MCPB No. 19-134 Sketch Plan No. 320190080 Battery Lane District Date of Hearing: December 12, 2019

RESOLUTION

RE: Preliminary Plan No. 120190240 Battery District

We have completed our review of the preliminary plans uploaded to eplans on January 24, 2020. A previous plan was reviewed by the Development Review Committee at its meeting on July 23, 2019. We recommend approval of the plan subject to the following comments:

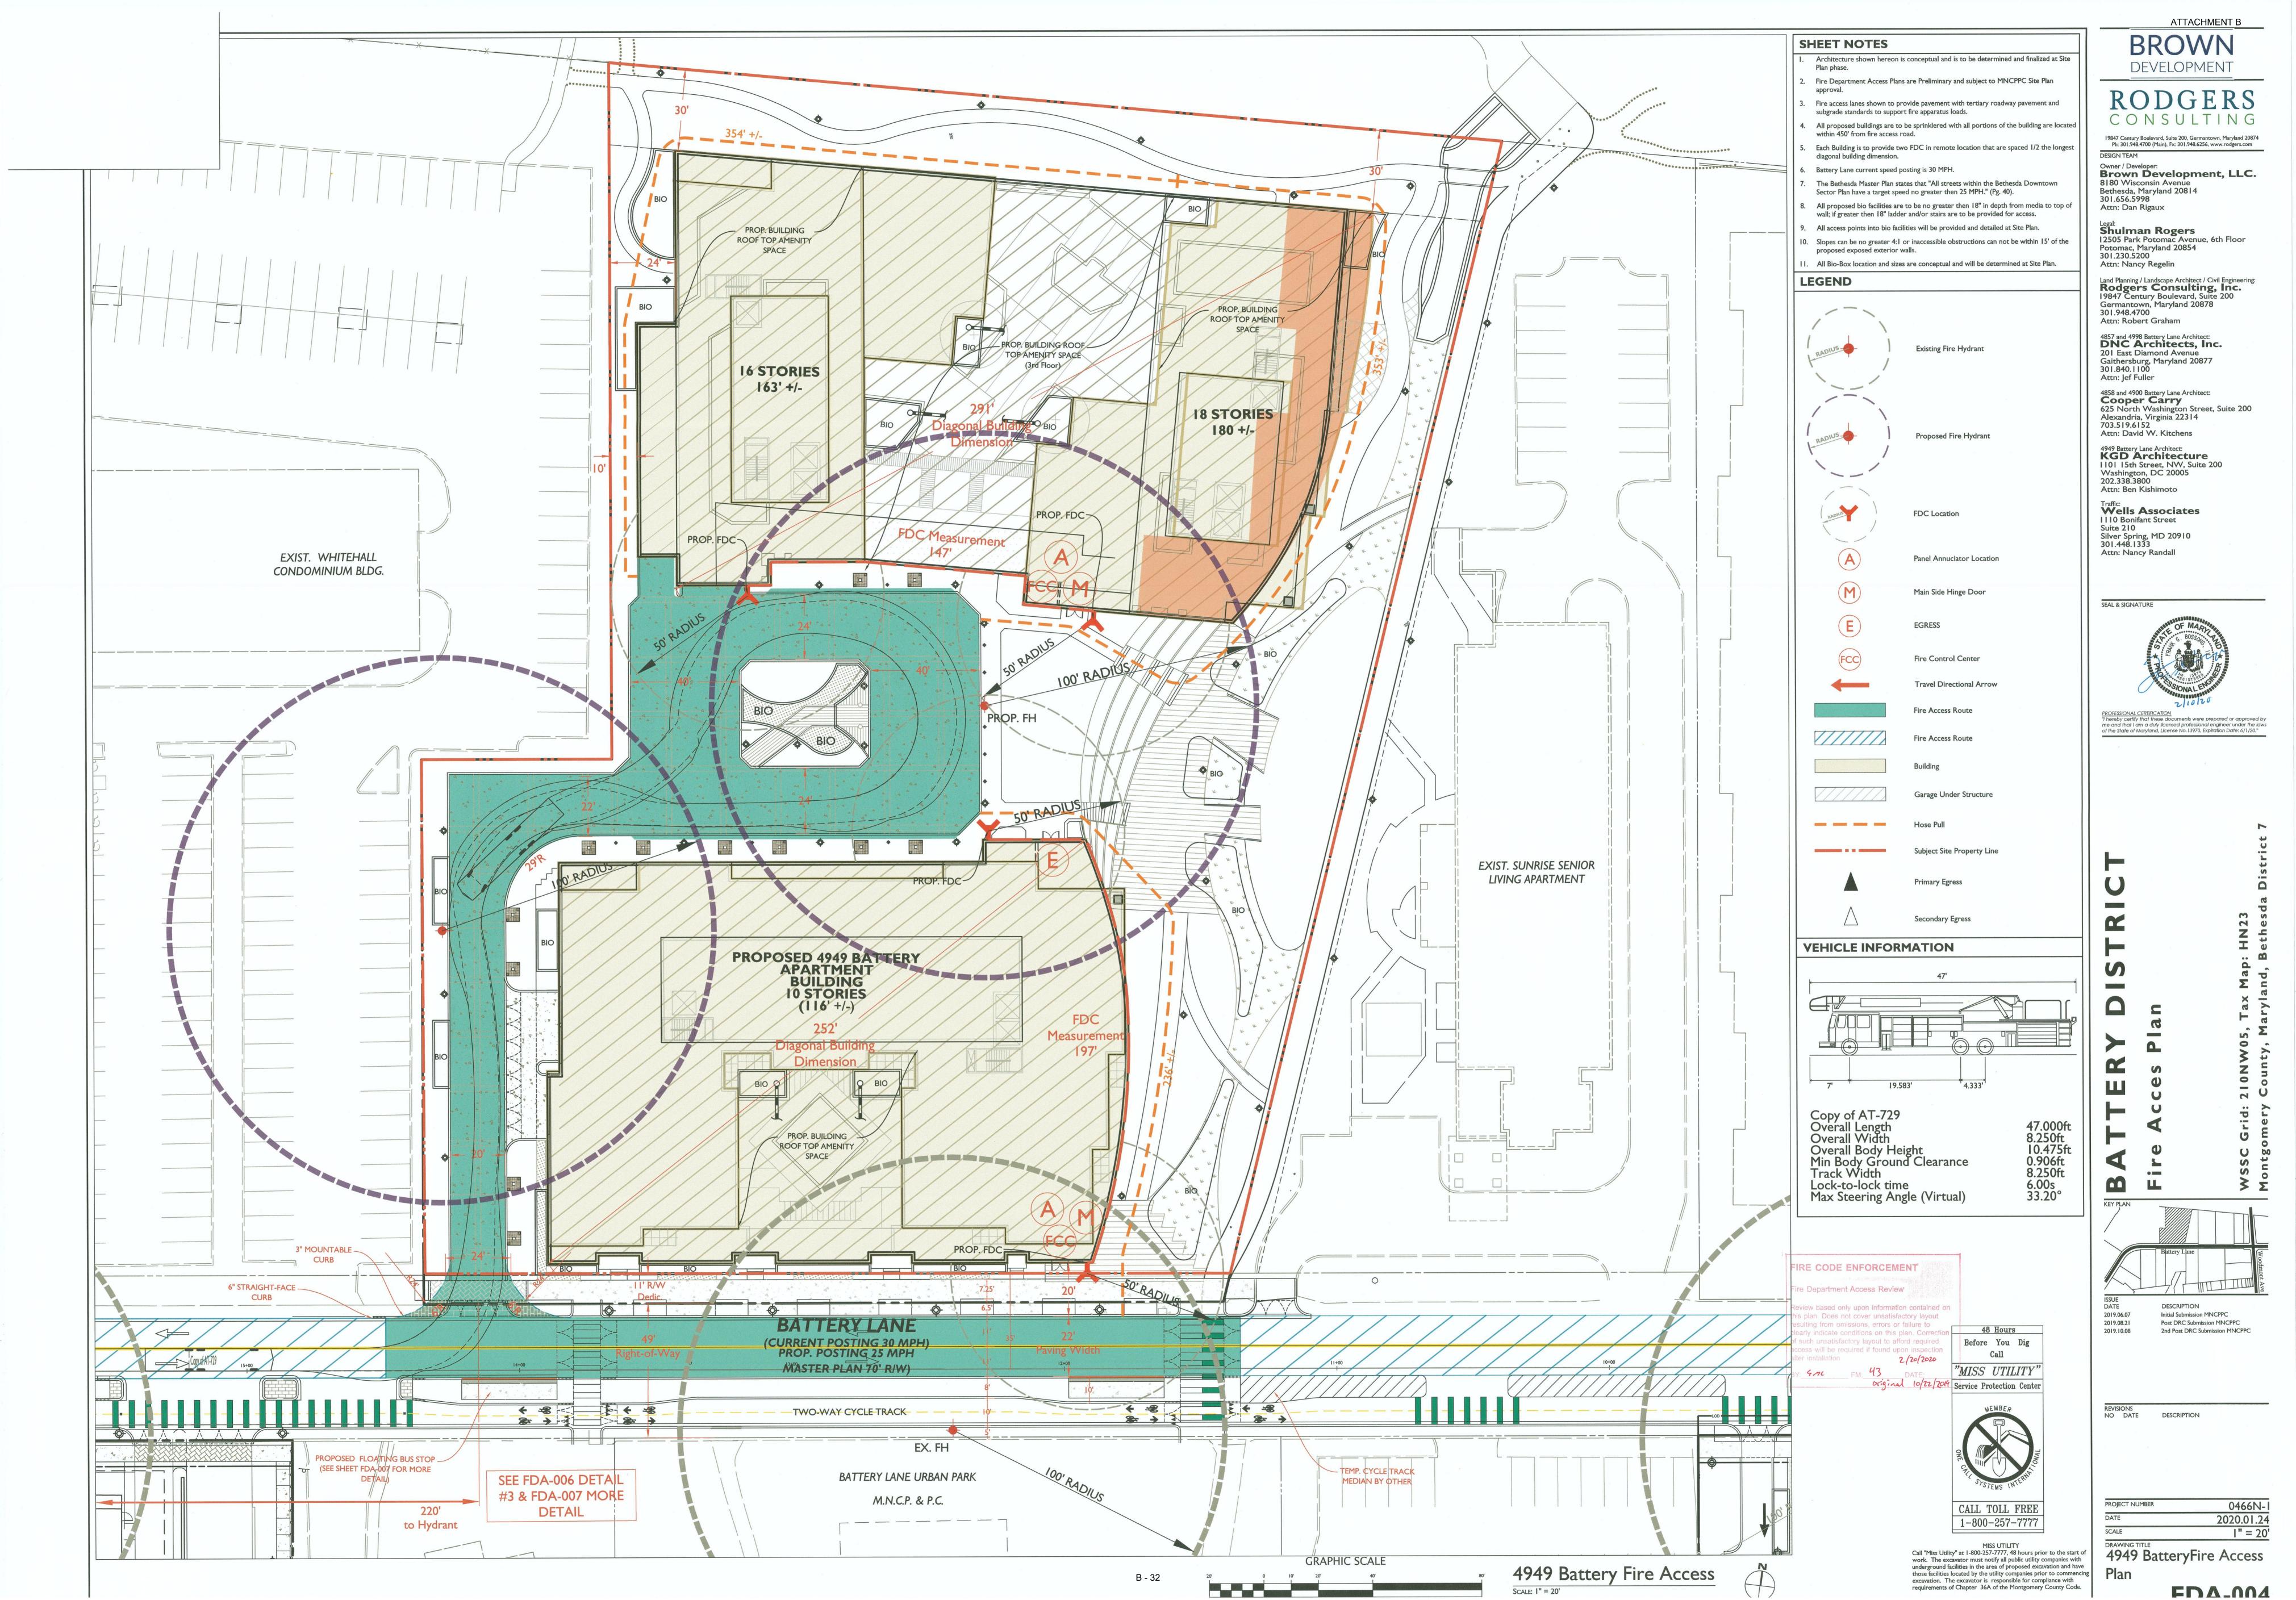
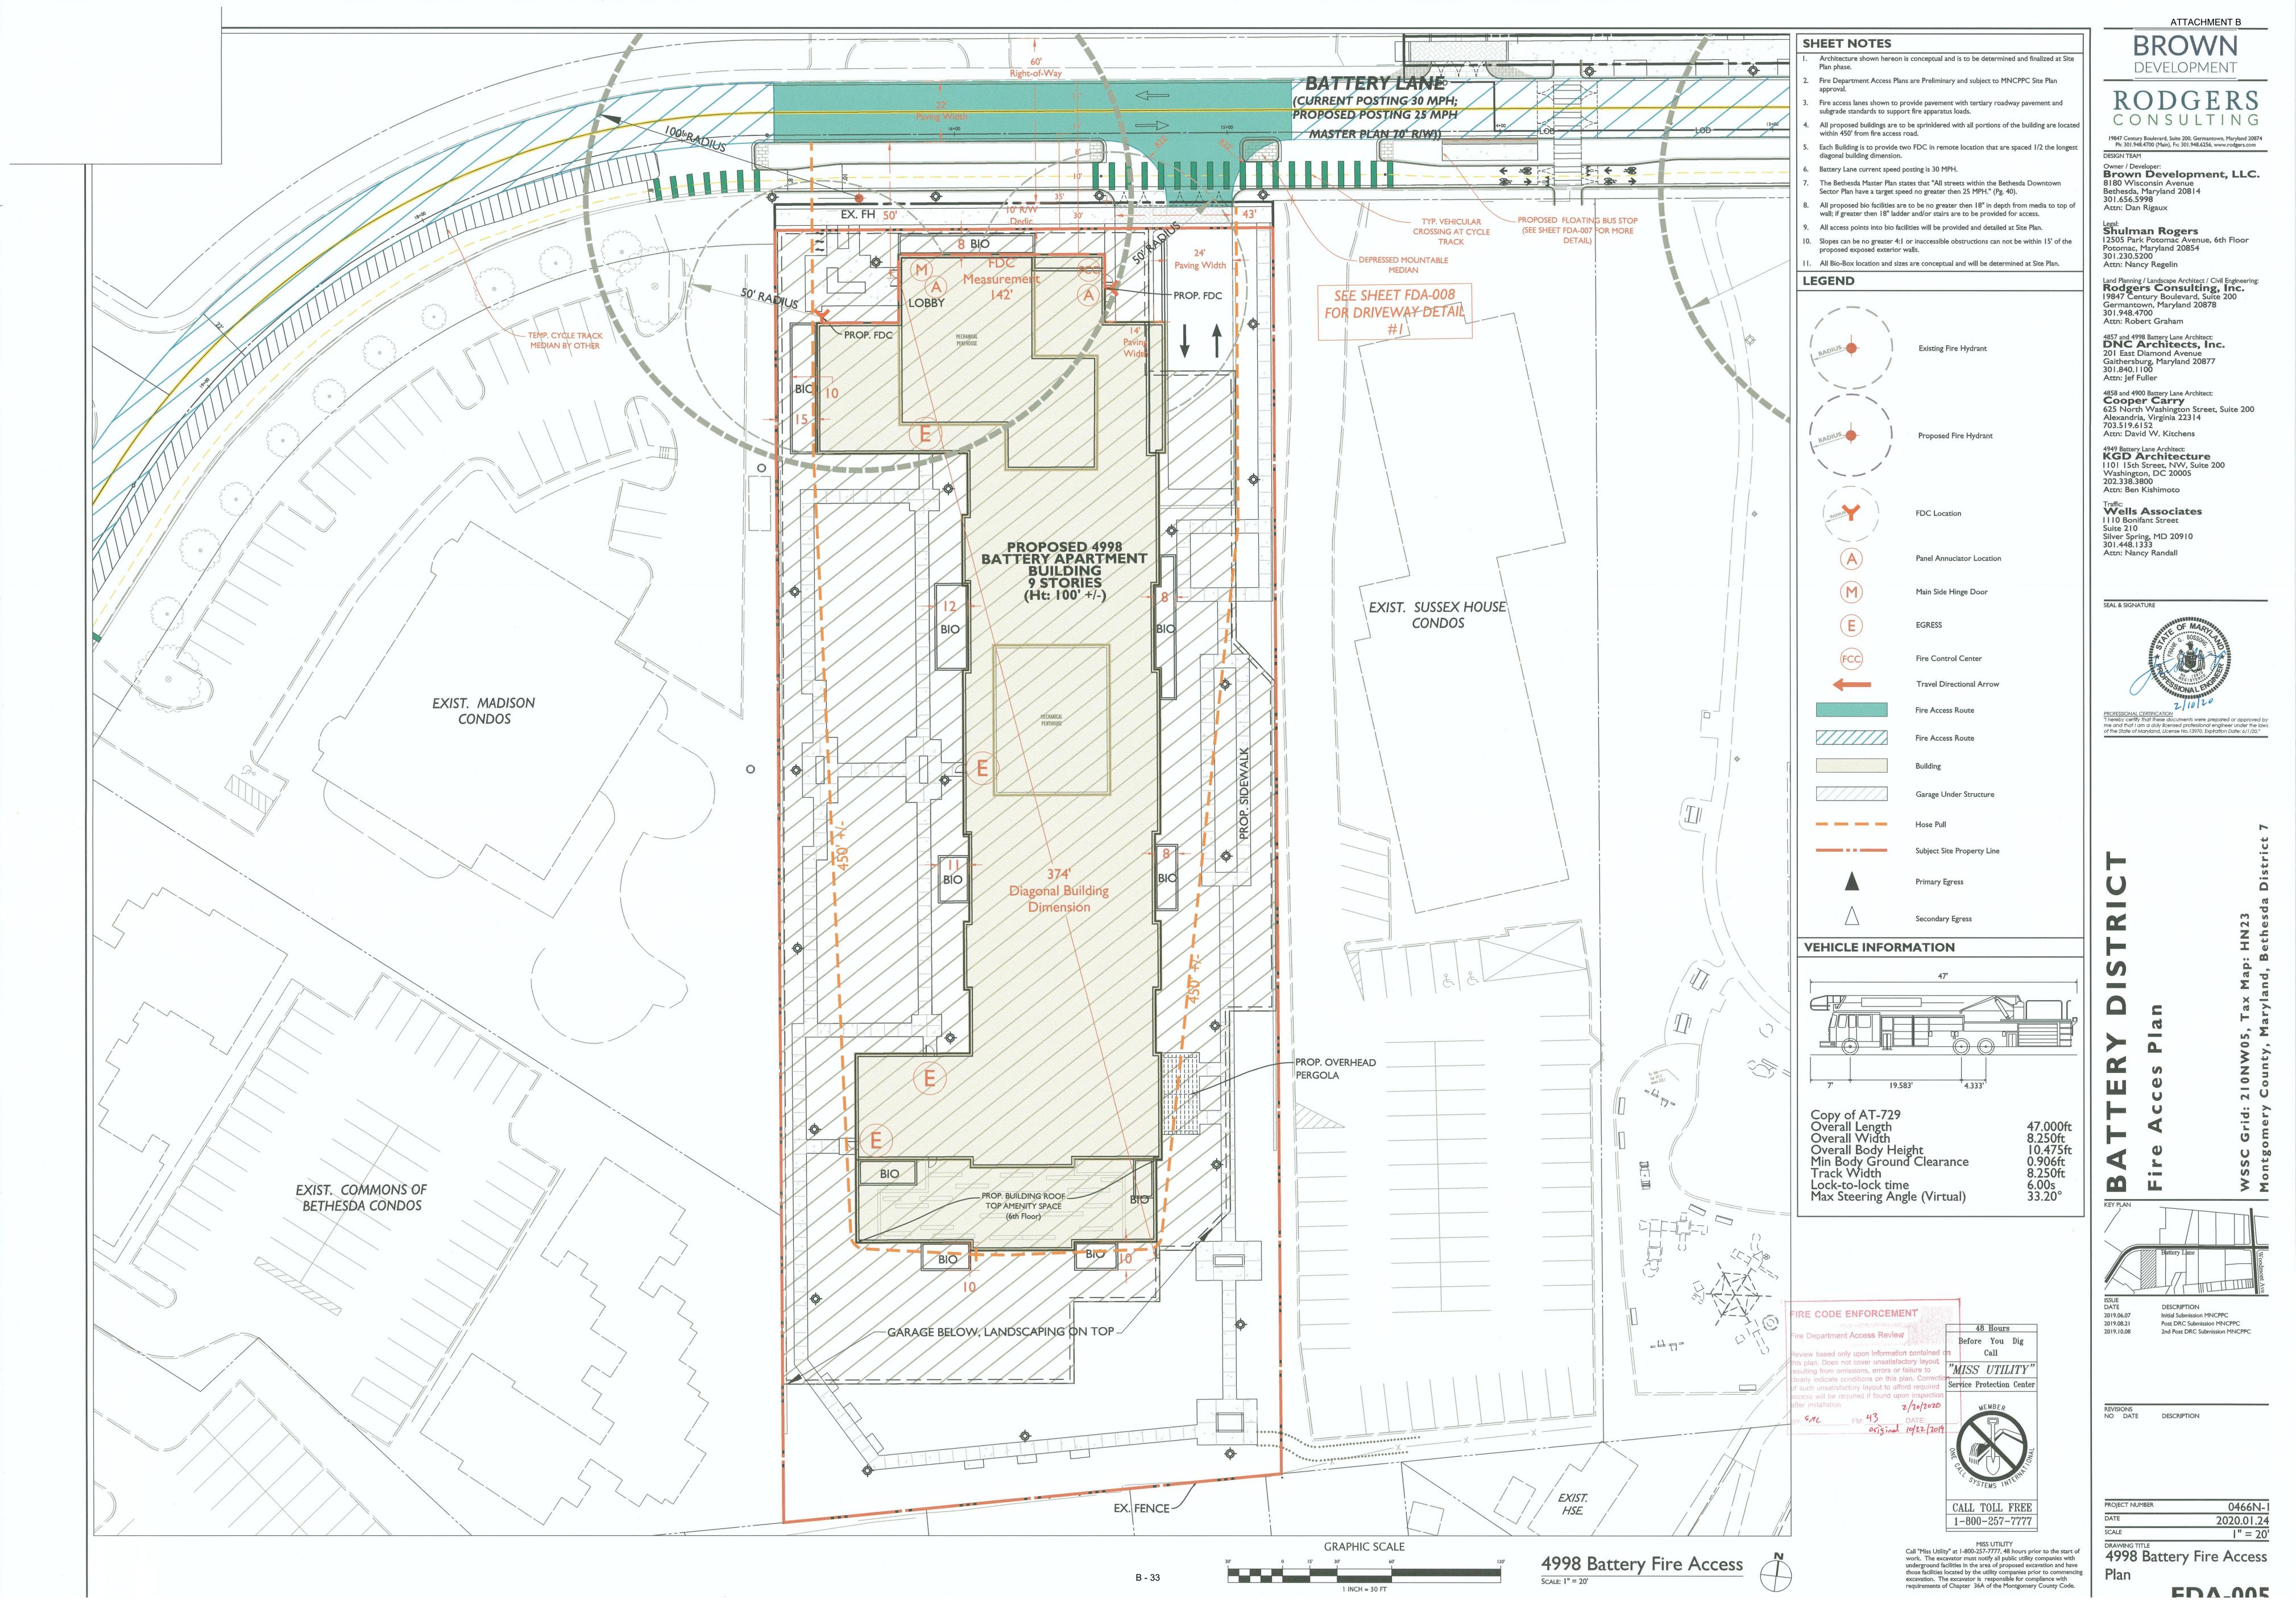
*** Engineer shall identify specific 3" mountable curb detail at Site Plan

*** Engineer shall further detail bike lane medians at fire department access driveways at Site Plan

******* GrassCrete GC2 surface shall not have a sod overlay

*** All fire lanes and fire department vehicular access paths are on grade (i.e. not on elevated decks)

*** Fire lanes orders to be submitted at Site Plan

2/20/2020 Revised Preliminary Plan - bikes lanes moved to south side of Battery Lane - add following comment to above:

*** Pedestrian access to bus stop at 4900 Battery Lane (Site C) shall not conflict with fire department vehicular access. Details to be submitted at Site Plan

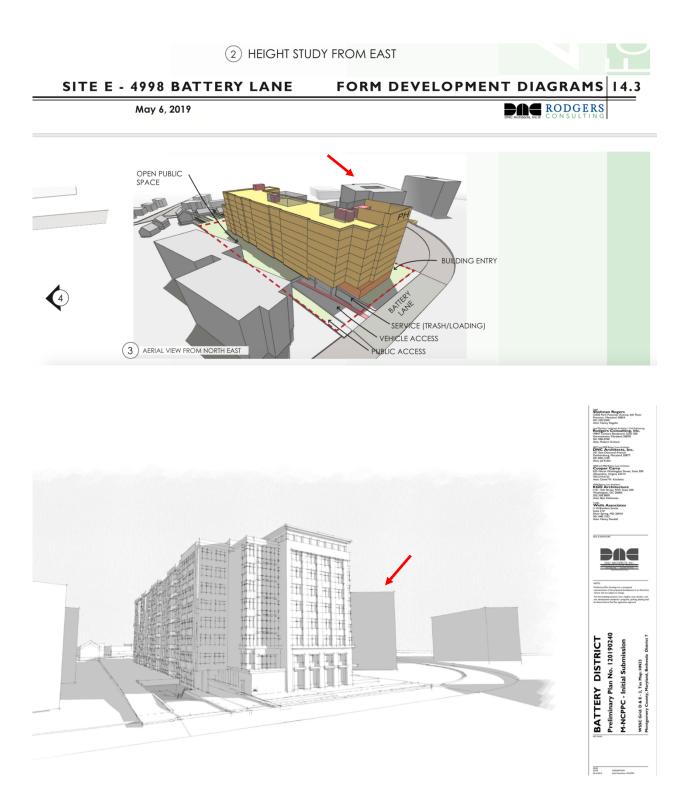
I own and live in Madison Park Condominium unit #701 at 5000 Battery Lane, Bethesda, which I purchased in 2001. I selected and invested in this particular unit because it faces south and has complete privacy and good views, which have also been enjoyed by many other unit owners, some of whom have lived in Madison Park since it was built 30 years ago. I have included images from sketches that have been submitted by the developer for review that demonstrate the impact of the proposed Parcel E on Madison Park Condominiums (see red arrows).

While I understand the desire of the developer to maximize profits by building a large building that will generate income from many apartment units, it would be reasonable and fair to require the developer to prepare and submit for consideration a reconfigured building massing alternative that is lower in height to the south (and perhaps higher to the north towards Battery Lane to accommodate). There is no downside for at least exploring this alternative, and it could greatly reduce the negative impact on Madison Park Condominiums. Otherwise, the benefit to the developer will literally be at the expense of Madison Park owners as the monetary value and enjoyment of our units goes down.
